SECTION 4.15 ASSESSMENT REPORT
Environmental Planning & Assessment Act 1979

DA No:	DA/544/2021
Property:	Lot 6 DP 38557, Lot 5 DP 38557, 47-49 Park Road, RYDALMERE NSW 2116
Proposal:	Demolition, tree removal and construction of a three storey residential flat building containing 18 units over basement car parking.
Date of receipt:	2 June 2021
Applicant:	Bluestone Projects Pty Ltd
Owner:	Mr G W Smith and Mrs G M Smith and FMH Nominees Pty Limited and Jaami Holdings Pty Limited and FMH Custodian Pty Limited and Rydalmere Holdings Pty Ltd
Property owned by a Council employee or Councillor:	The site is not known to be owned by a Council employee or Councillor
Political donations/gifts disclosed:	None disclosed on the application form
Submissions received:	Nil
Conciliation Conference Held:	No
Recommendation:	Approval, subject to conditions
Assessment Officer:	Matthew Golebiowski

Figure 5: Cross section of the proposed building, showing extent of the non-compliance

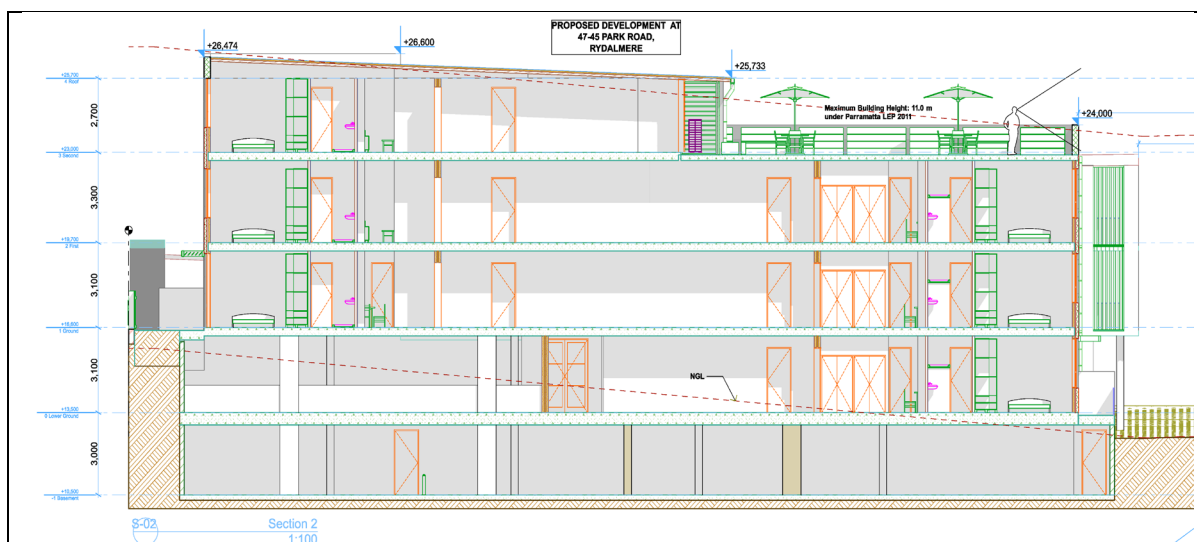
Acid sulphate soils	An Acid Sulphate Soils Management plan is not required to be prepared.
Earthworks	Council's Development Engineer has reviewed the application and considers that the proposed earthworks are satisfactory.
Flood planning	The site is not identified by council as being flood prone.
Biodiversity protection	The site is not identified on this map
Water protection	The site is not identified on this map
Development on landslide risk land	The site is not identified on this map.
Affected by a Foreshore Building Line	The site is not located in the foreshore area.
Bushfire Prone Land	The site is not identified on this map.
Exceptions to development standards	The proposal seeks a variation to Clause 4.3 – Height of Buildings. Please see discussion below.
Clause 4.6 Exceptions to Development Standards	
The proposal seeks a height of 12.5m, which exceeds the 11.0m Building Height development standard by 1.5m (approximately 13.6% variation).

The applicant has submitted a written request seeking variation to the maximum building height prescribed by Clause 4.3, as required by Clause 4.6 of the PLEP 2011. Clause 4.6(2) provides that in certain circumstances, consent ...*may be granted for development even though the development would contravene a development standards imposed by this or any other environmental planning instrument.*

In this instance, Council is satisfied that applicant's Clause 4.6 Statement adequately addresses the matters in Clause 4.6(3) of the PLEP2011. It has provided a suitable argument as to why the standard is unreasonable and unnecessary in this case and demonstrates sufficient environmental planning grounds to justify contravening the Height of Building development standard.
